Great River Energy Responses to EA Questions

Re: **Responses of Great River Energy to Energy Environmental Review and Analysis
Questions for Development of Environmental Review, Questions 1-9**

In the Matter of the Application of Great River Energy for a Route Permit for the
Palisade 115 kV Project in Aitkin County, Minnesota

Docket No. ET2/TL-15-423

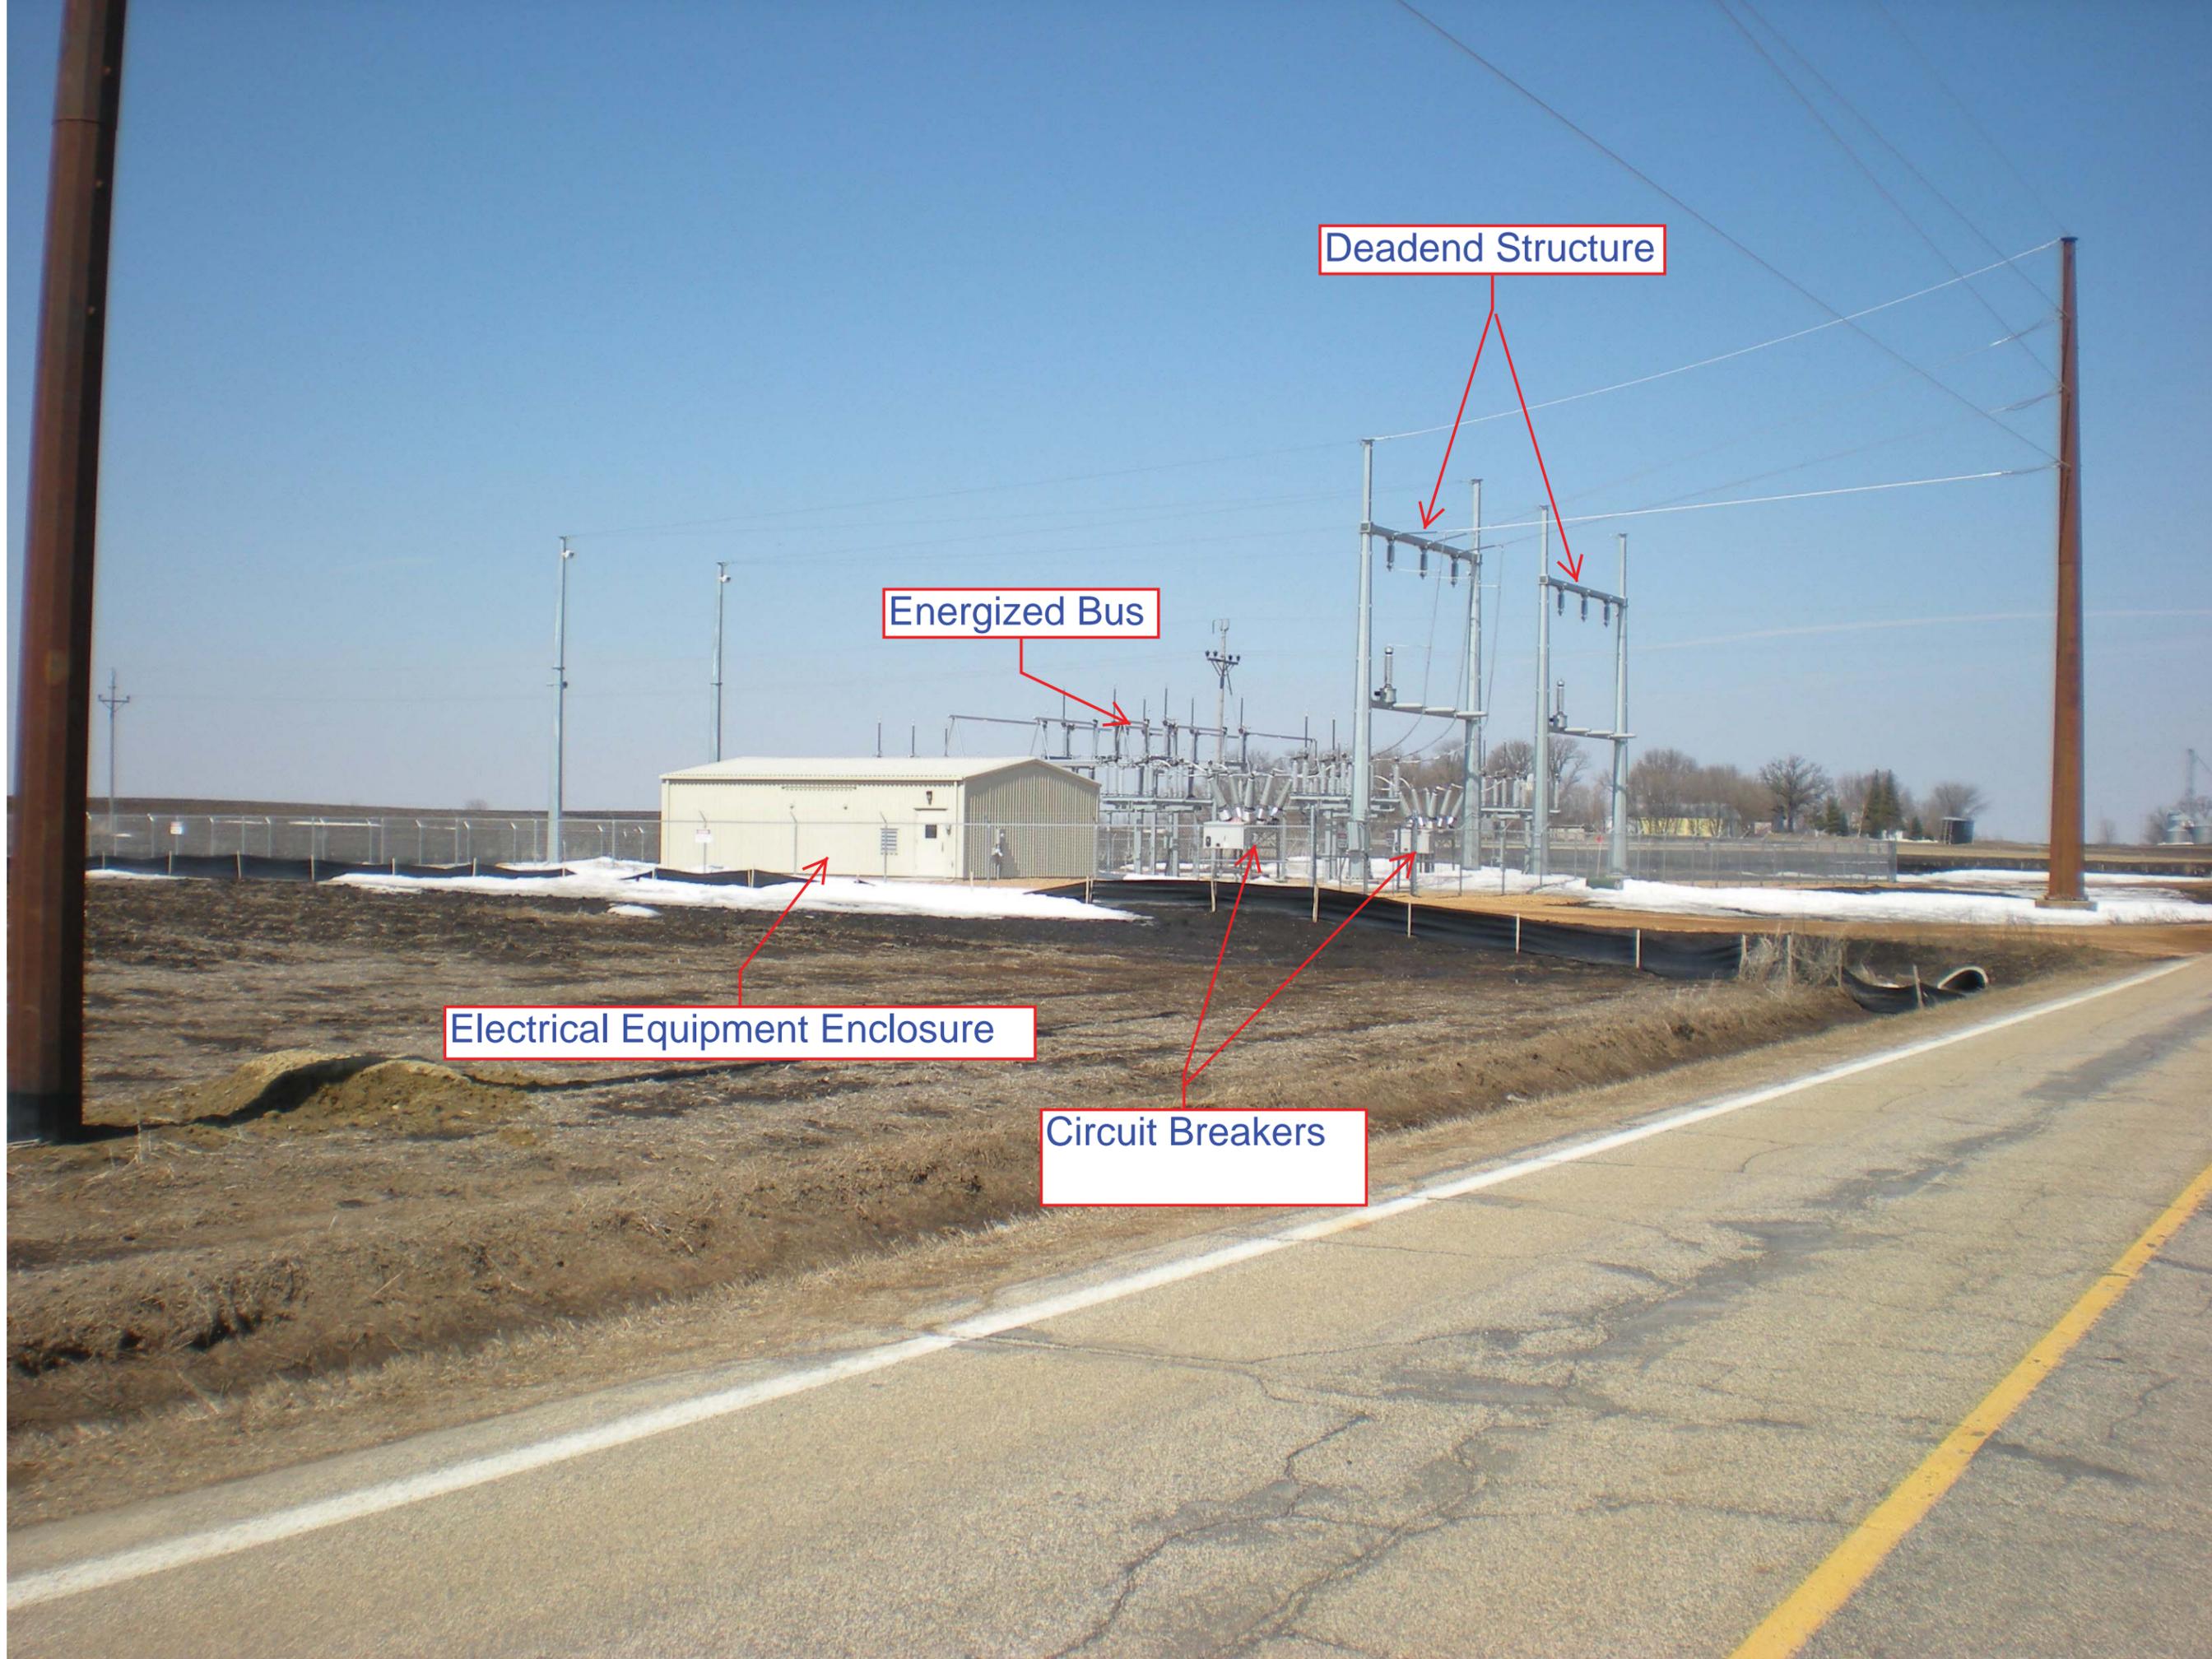
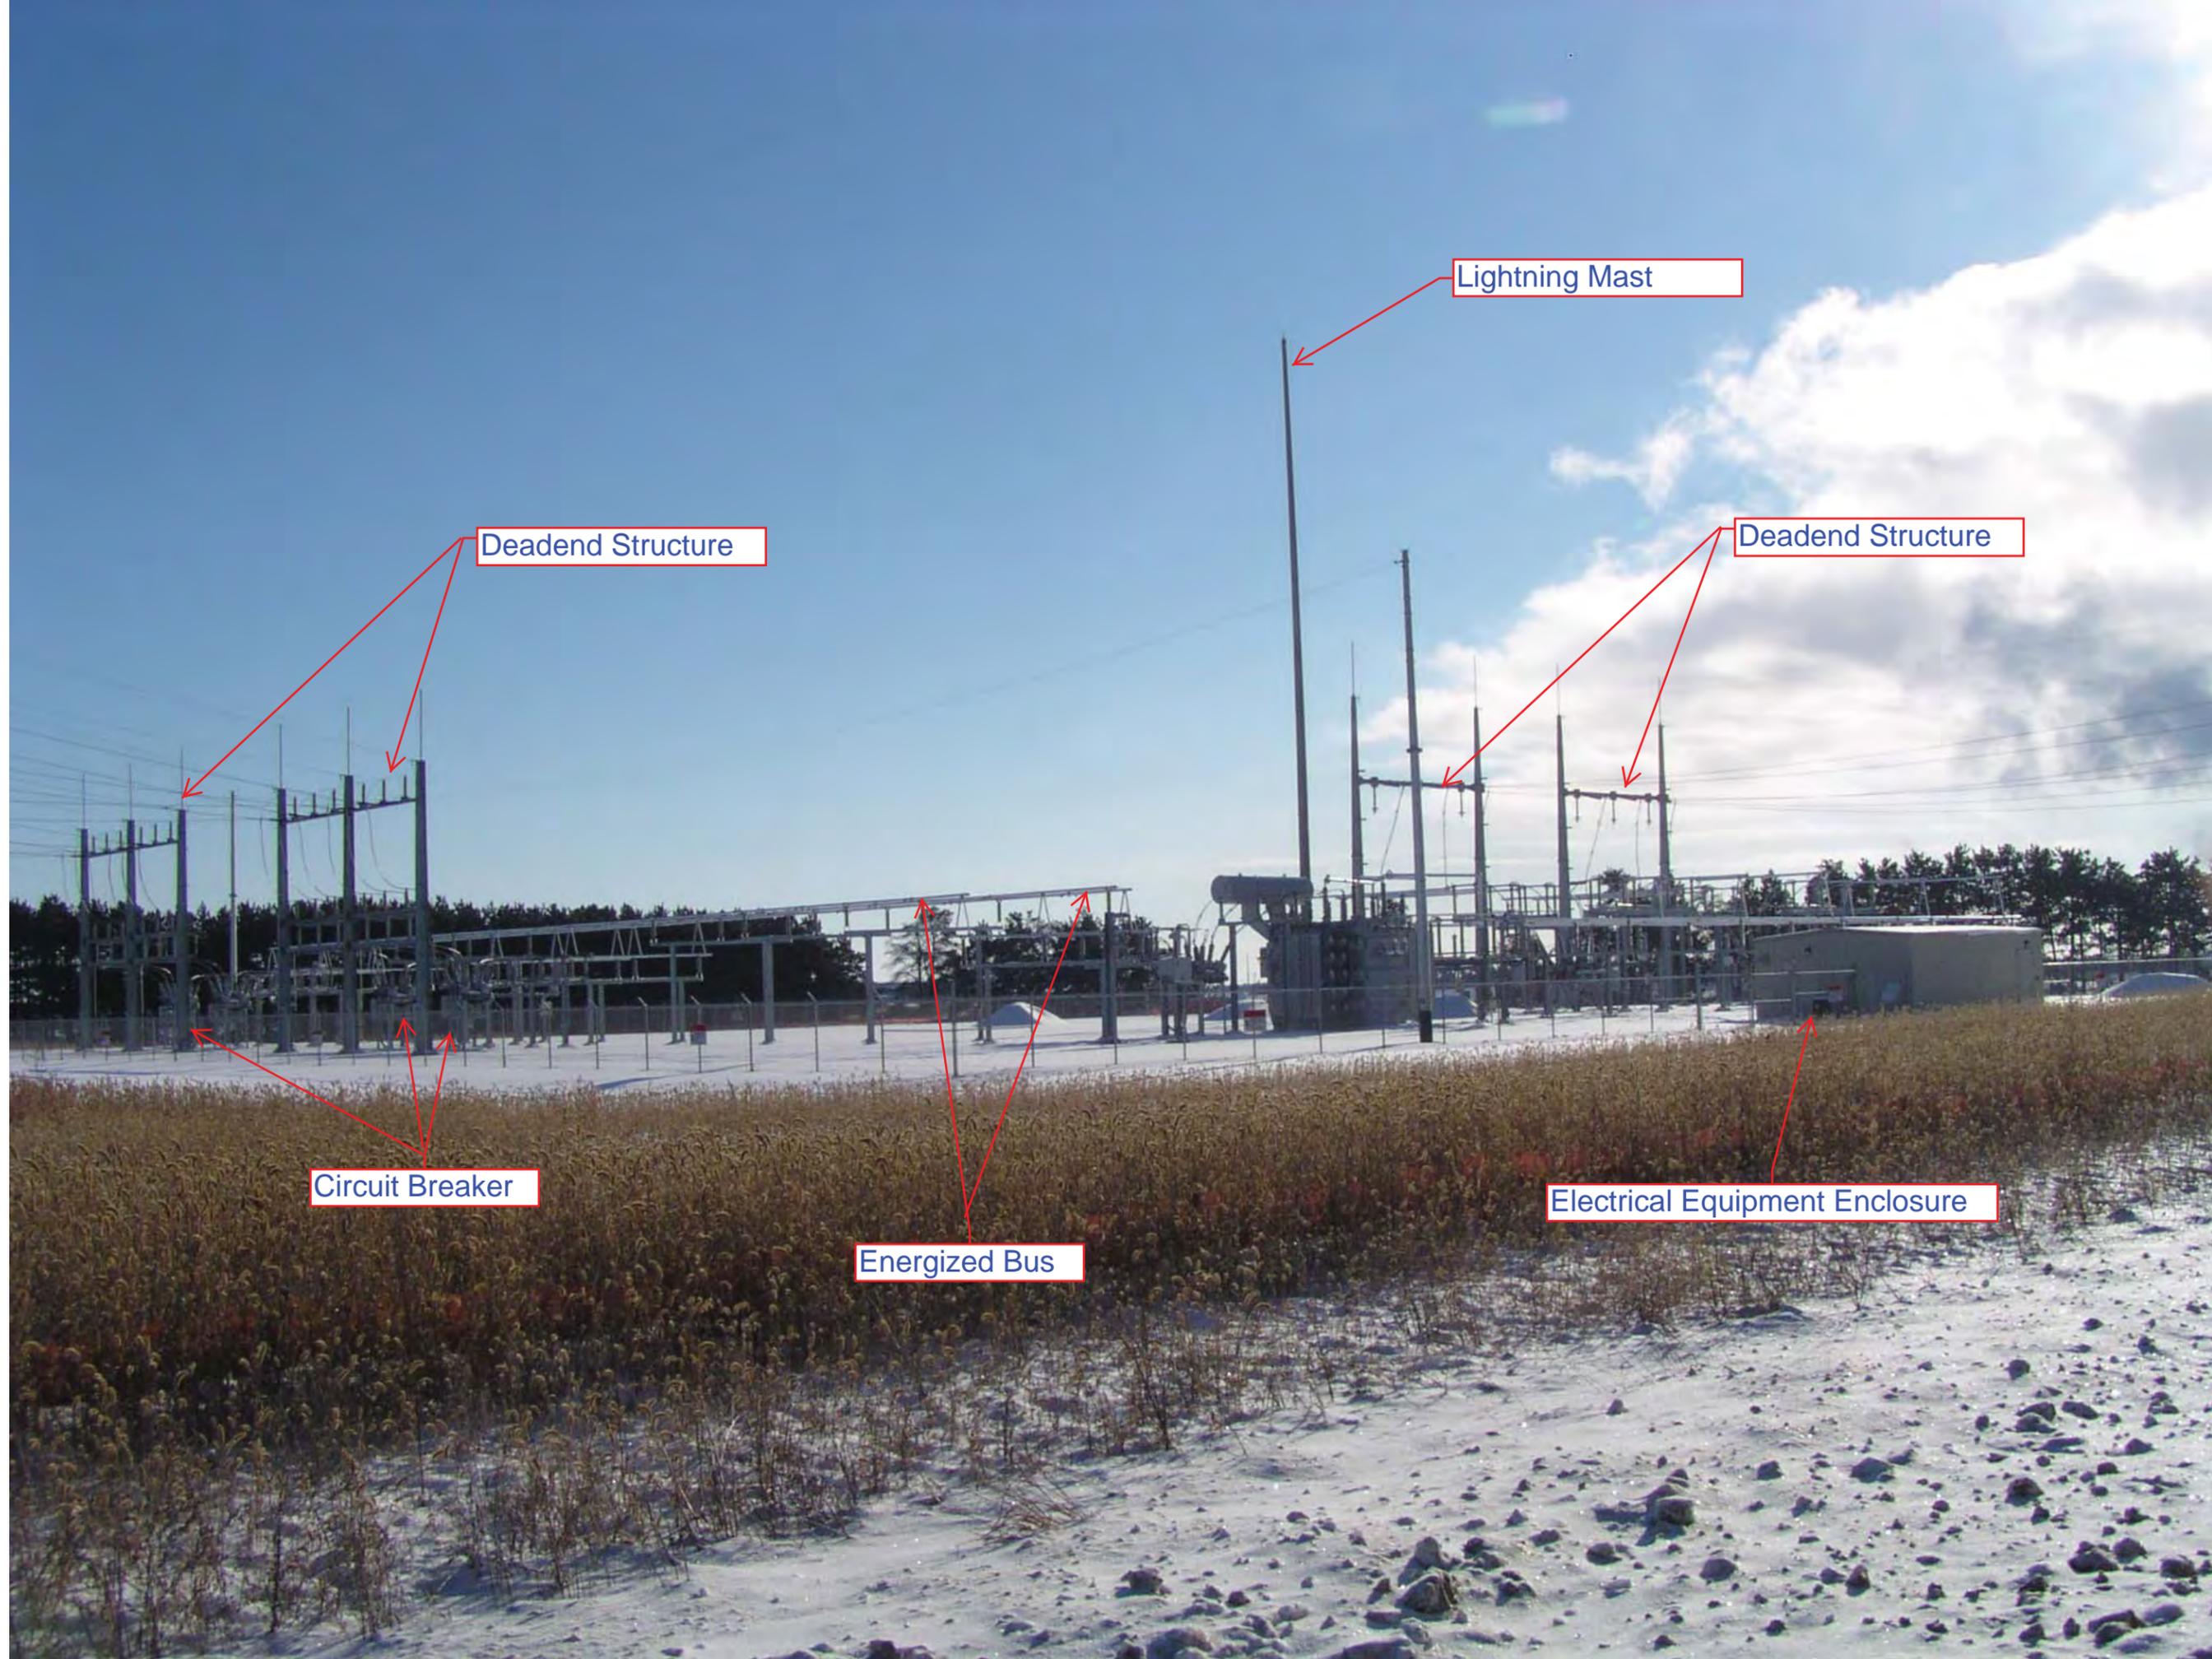
- Description of the current land use at the proposed breaker station location
- Description of equipment (type of equipment, relative height of major equipment) at the breaker station
- Description of lighting
- Description of fence including height and provisions for ingress/egress to the facility.
- Description of any cleared area to be maintained outside of the fenced area, such as for parking.
- Description of construction
- Description of operations and maintenance procedures
- Photo or illustration of a similar breaker station

- See site examples attached.
